Theater Missile Defense Extended Test Range

Final
Environmental Impact Statement

November 1994

Volume I begins with the Executive Summary and Acronyms and Abbreviations. Section 1.0 of the Final EIS contains the introduction. Section 2.0 contains the additions and revisions to the Draft EIS and to the Supplement to the Draft EIS. Section 3.0 contains the responses to comments that were made on the two documents, and Section 4.0 includes an index to the commenters. Section 5.0 contains the agency comment letters and responses that pertain to the Draft EIS and the Supplement to the Draft EIS, while Section 6.0 lists the references used in the preparation of the Final EIS. Section 7.0 contains the list of preparers of the EIS, and Section 8.0 contains the distribution list for the document. Section 9.0 contains copies of the transcripts, exhibits, and written comments pertaining to the Draft EIS relevant to the Western Range Candidate Test Area. Section 10.0 contains copies of the transcripts, exhibits, and written comments pertaining to the Draft EIS relevant to the Eglin Air Force Base Candidate Test Area. Appendix A contains a discussion of cumulative impacts for the EIS, and Ap

Figure 3.3-5

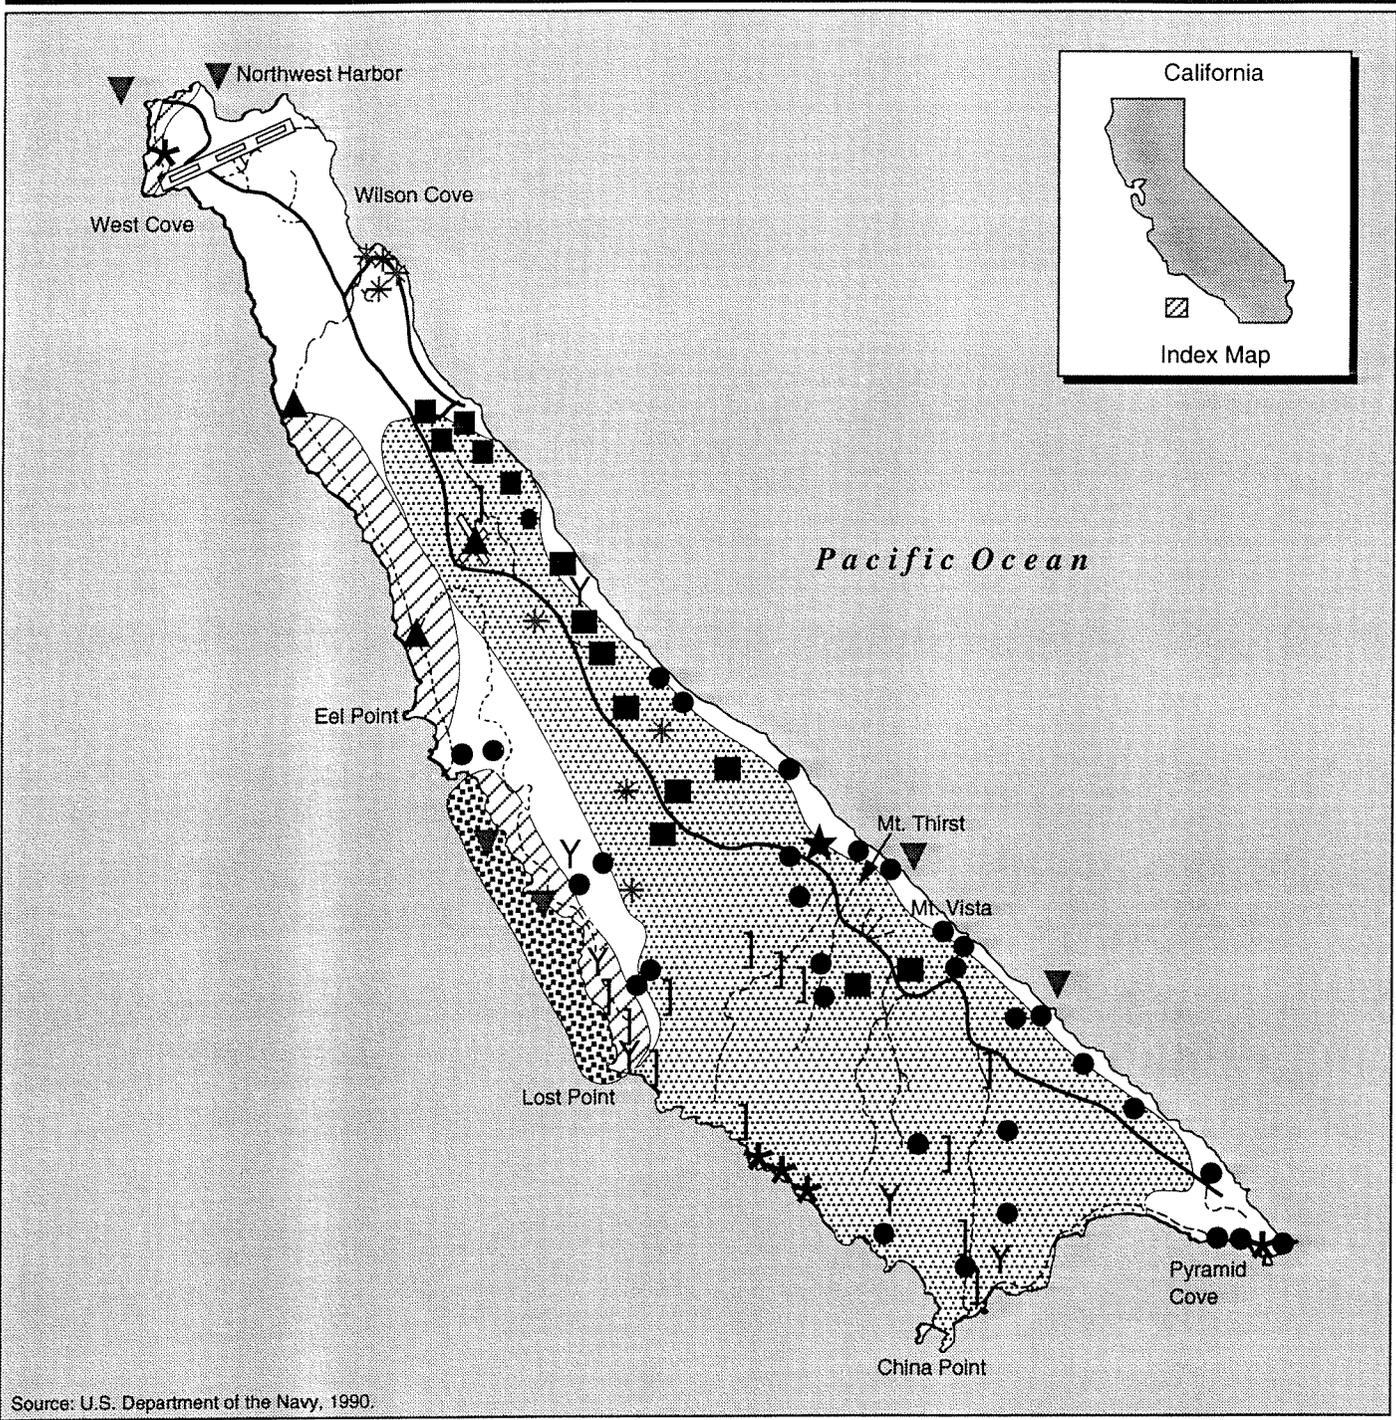
Page 3-192, figure 3.3-5: Figure has been revised as shown.

Figure 3.4-1

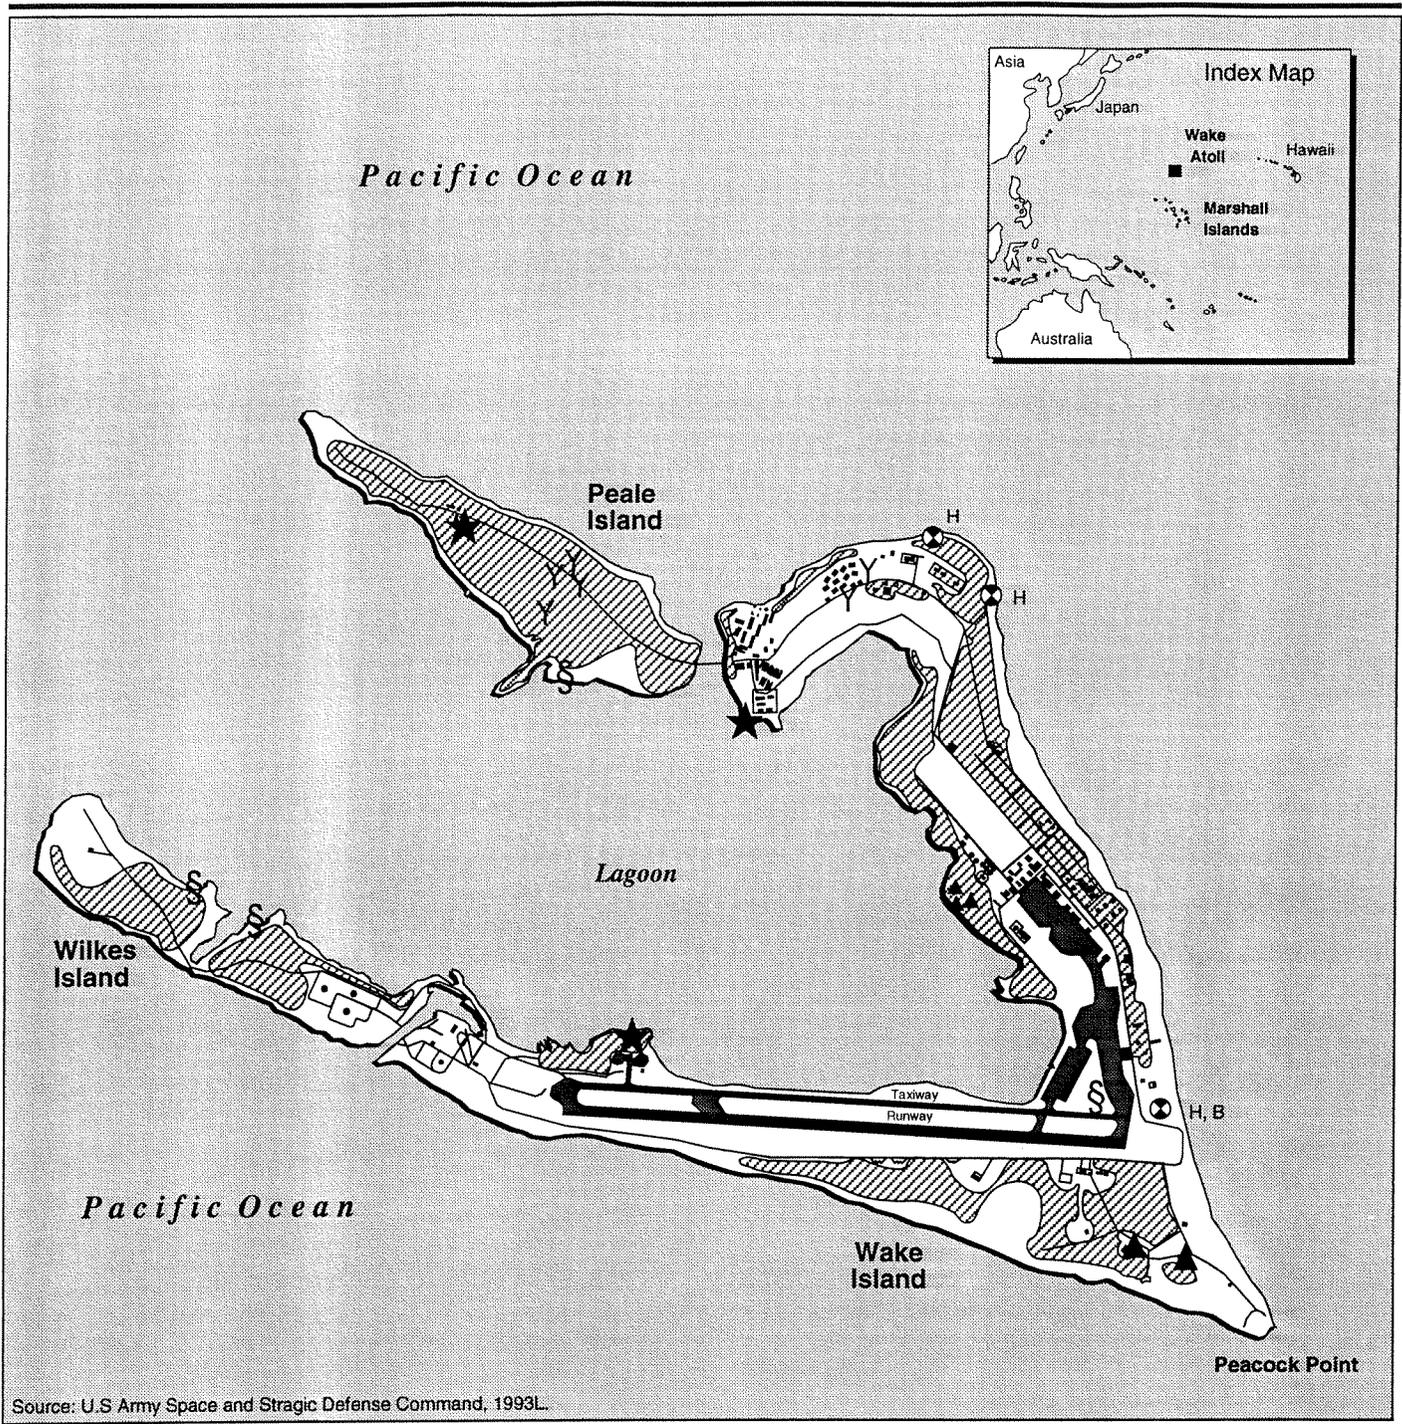
Page 3-263, figure 3.4-1: Figure has been revised as shown.

Figure 3.4-2

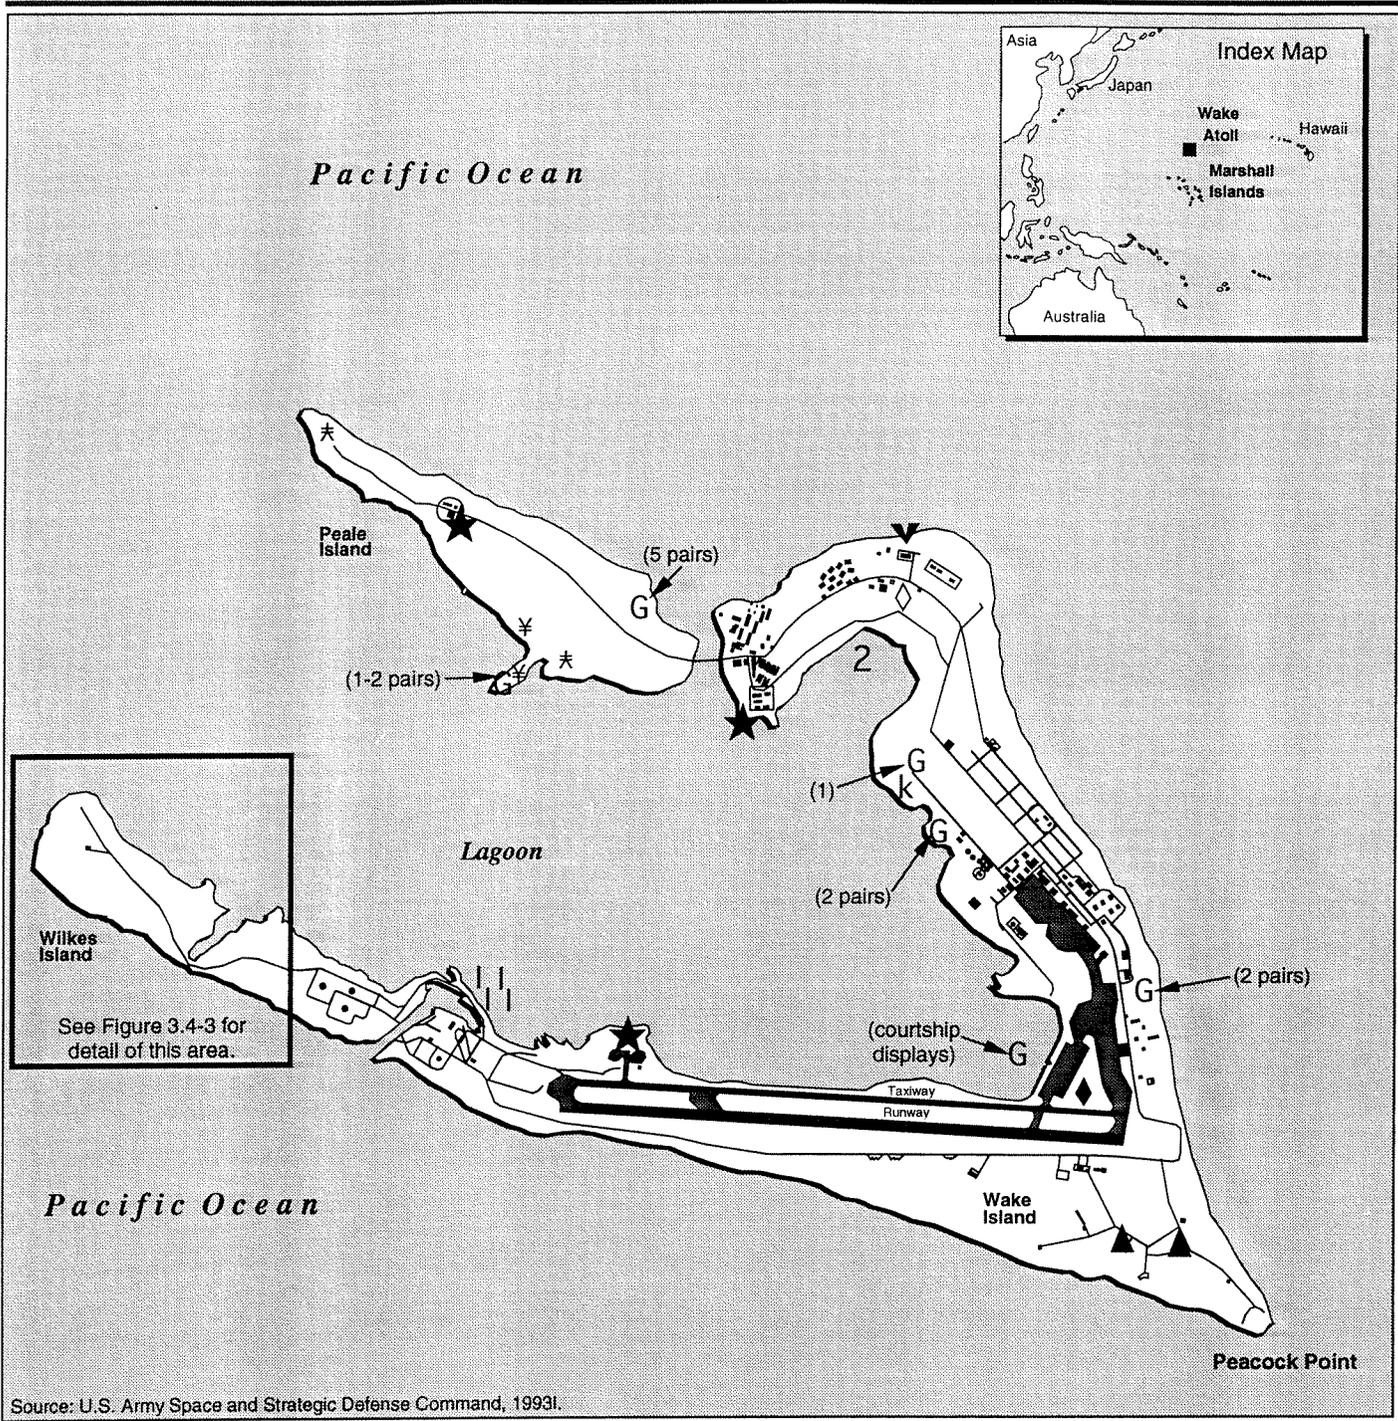
Page 3-264, figure 3.4-2: Figure has been revised as shown.

Figure 4.1-1

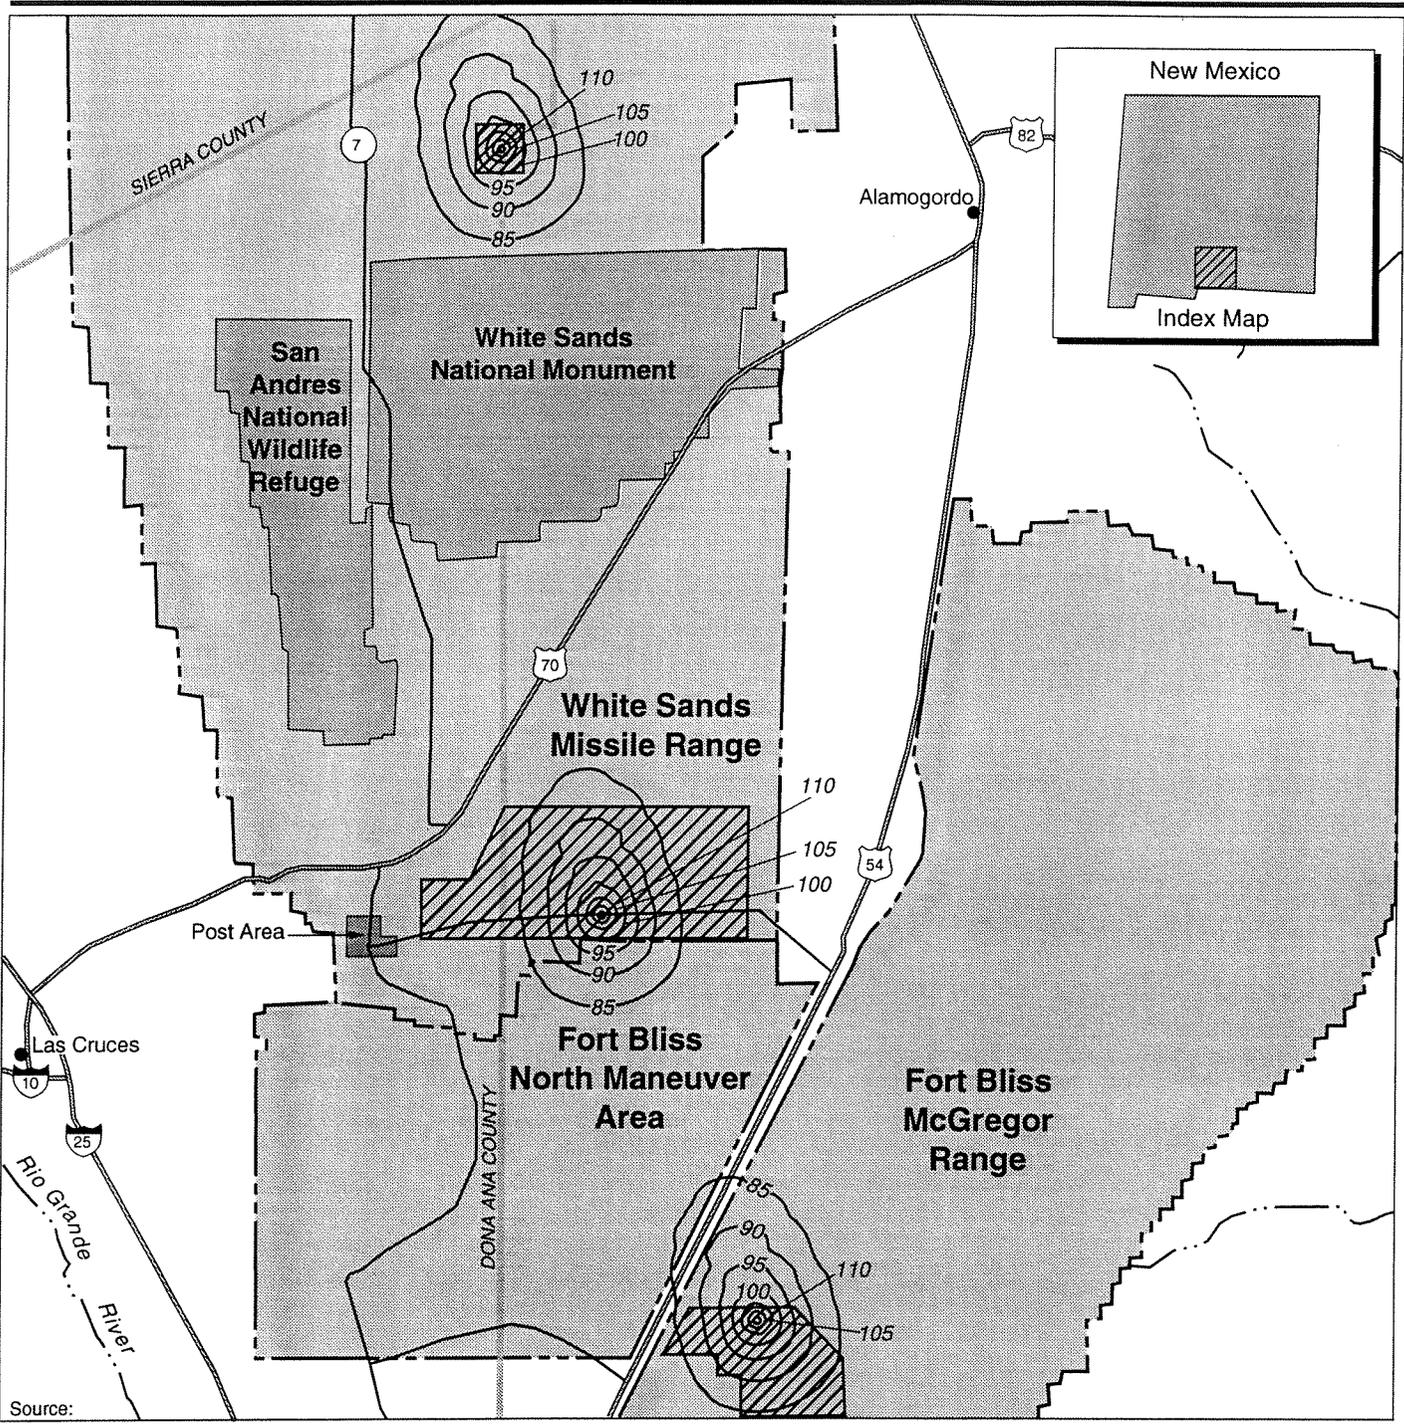
Page 4-44, figure 4.1-1: Figure has been revised as shown.

Figure 3-1

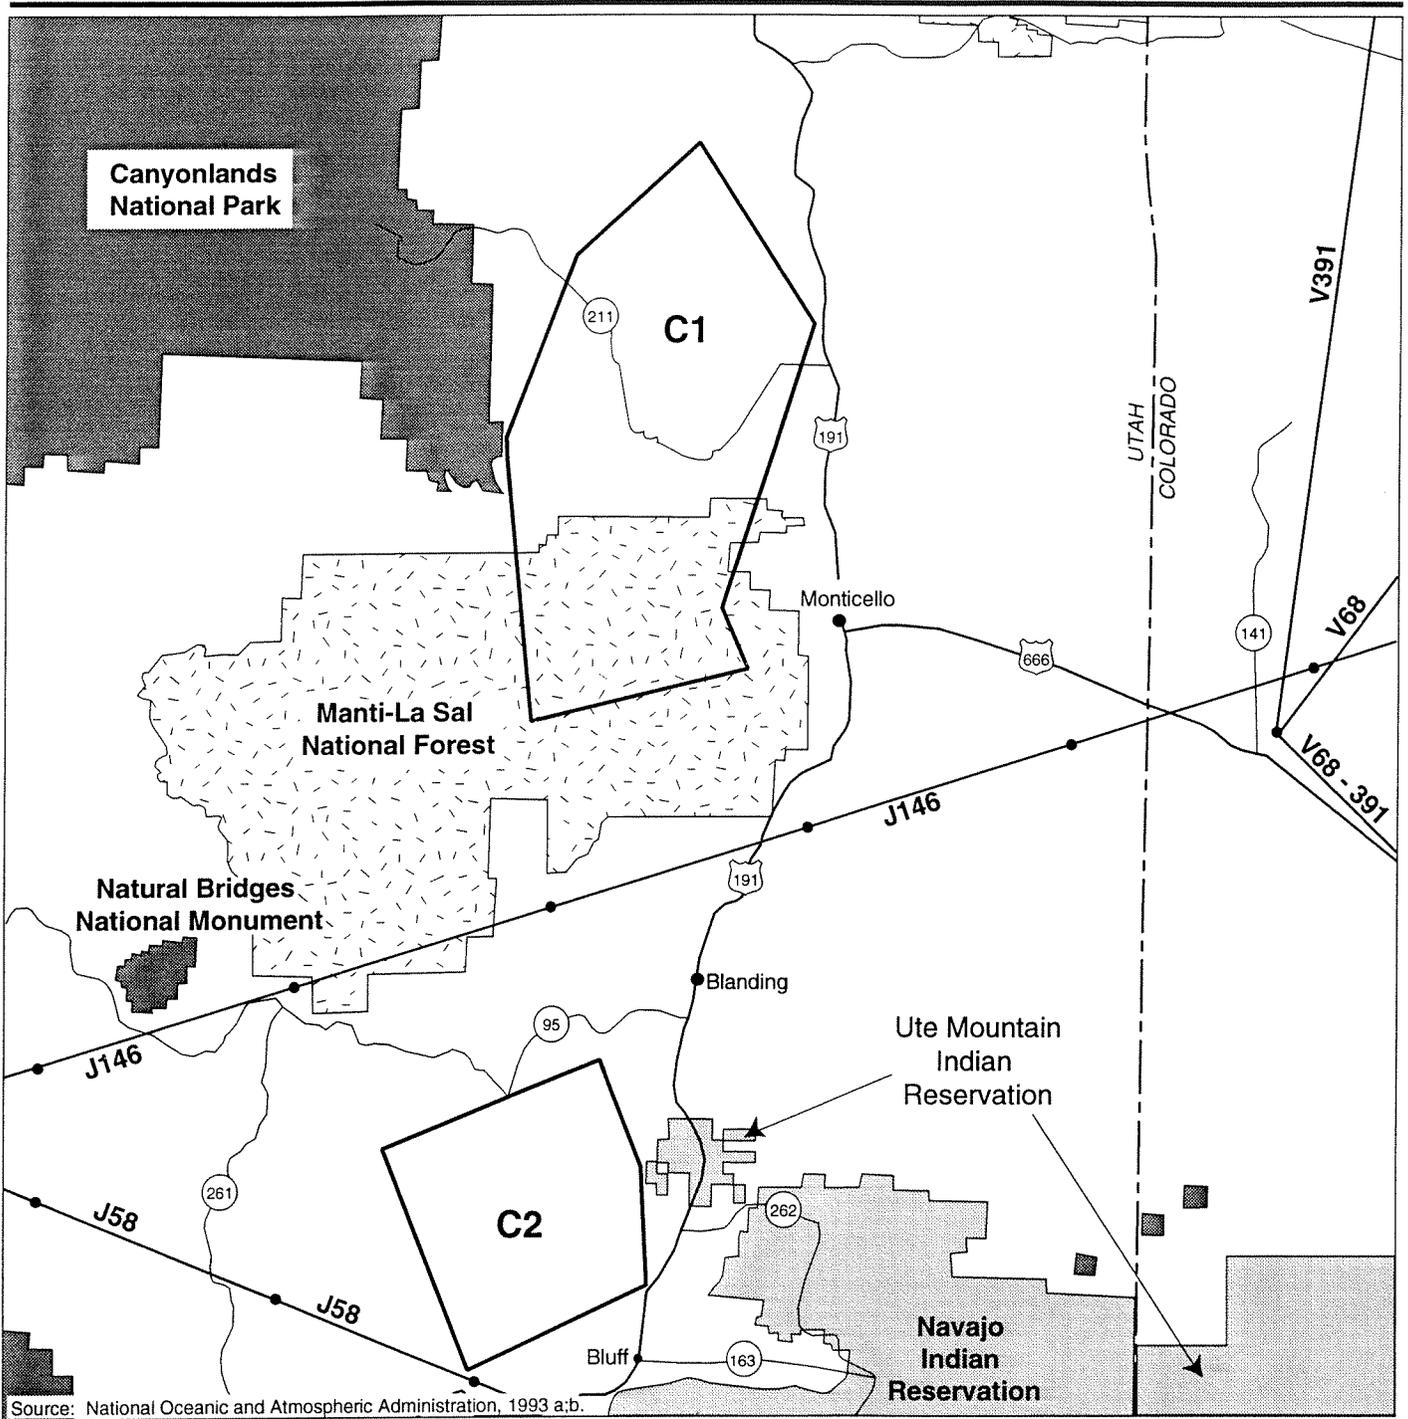
Page 3-3, figure 3-1 has been revised as shown.
